■ Specification and Appearance Differences Due to Specification Changes

The following specifications have been changed, but there are no problems with use.

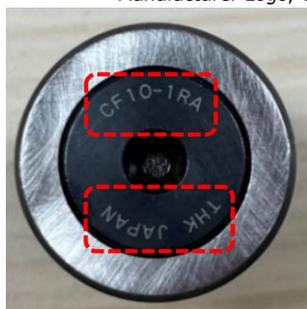
Type	Change Details	Before Change	After Change
CFAP	Material (Main Body)	SUJ2	SUJ2 Equivalent
CFFAP	Material (Hex Nut)	S45C	General Structural Steel
CFAPH	Appearance (Engraving)	Manufacturer Part Number, Manufacturer Logo, Country of Origin	MISUMI Part Number, MISUMI Logo
CFFAPH	Packaging	Individual Bag (Without Outer Box)	Individual Bag (With Outer Box)
